**PLANNED UNIT DEVELOPMENT,
PLANNING APPROVAL &
SUBDIVISION STAFF REPORT**

Date: February 19, 2009

St. Luke's Episcopal Upper School

1400 South University Avenue
(South side of University Boulevard, 490'± East of Grelot Road)

SITE PLAN

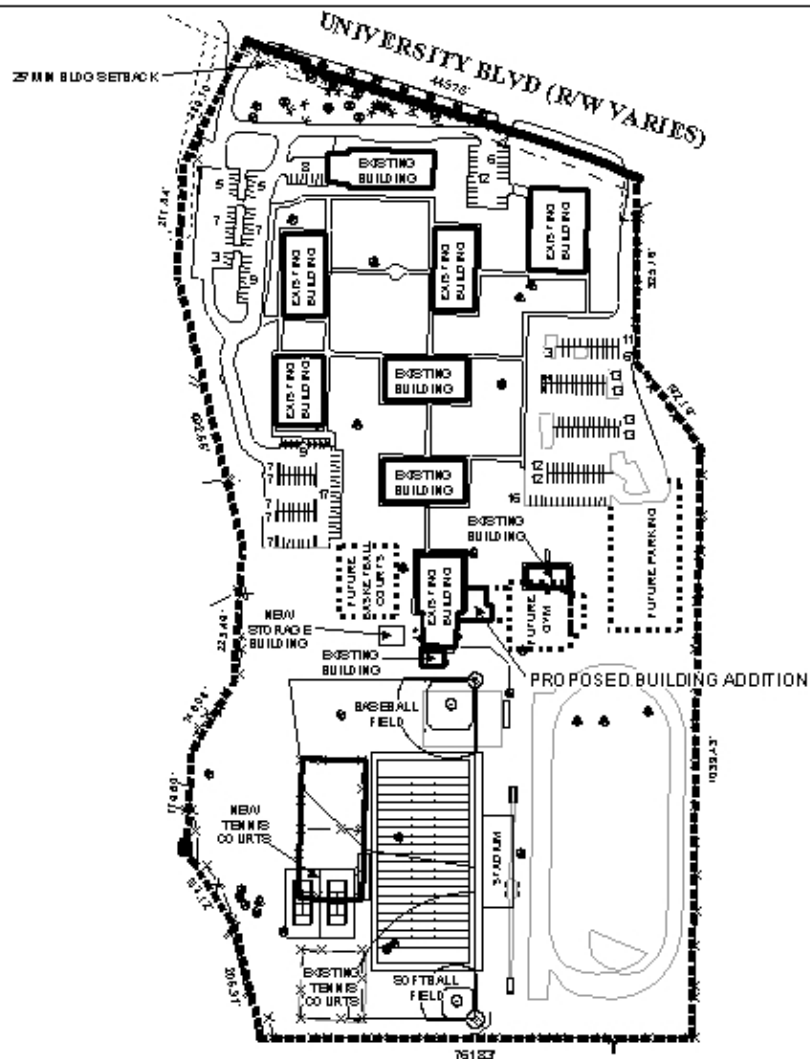
It should be noted that the westernmost curb cut seems to be within the adjacent undeveloped property; therefore, a condition noted on the site plan stating that a Planned Unit Development (PUD) would be required when this site is developed.

No on-site storm water detention facilities are depicted on the site plan, however such facilities may be required due to the extent of the proposed new development.

There is no indication on the site plan as to the proposed location of any dumpster or other waste storage facility. The location of the storage area for the dumpster must be indicated on the site plan, and the location and required screening must comply with Section 64-4.D.9. of the Zoning Ordinance, as well as with all other applicable regulations.

Regarding compliance with the tree and landscape requirements of the Zoning Ordinance, the applicant illustrates a significant number of frontage trees along South University Boulevard; however, no percentage of frontage landscaping is illustrated. Since no addition is illustrated or proposed within the front of the existing buildings and the total existing landscaping of 70 percent greatly exceeds the minimum requirements of the Ordinance, the approval should be approved based on the percentage of front landscaping that exist today.

As the new construction will be adjacent to existing residences, the applicant should ensure that any lighting provided on the site will comply with the Zoning Ordinance requirement that states that lighting *"shall be so arranged that the source of light does not shine directly into adjacent residential properties or into traffic."* Therefore, the application should provide photometric information for electrical requirements, if lighting is proposed for the addition to the gymnasium.

5. provision of sidewalks along the street frontage;
6. illustration of any necessary dumpster or trash receptacle, with **minor** revisions to parking and circulation layout to be approved by Planning staff, if necessary;

7. full compliance with the total landscaping and tree planting requirements;
8. full compliance with all municipal codes and ordinances; and
9. submission of a revised site plan reflecting the conditions prior to the issuance of any permits
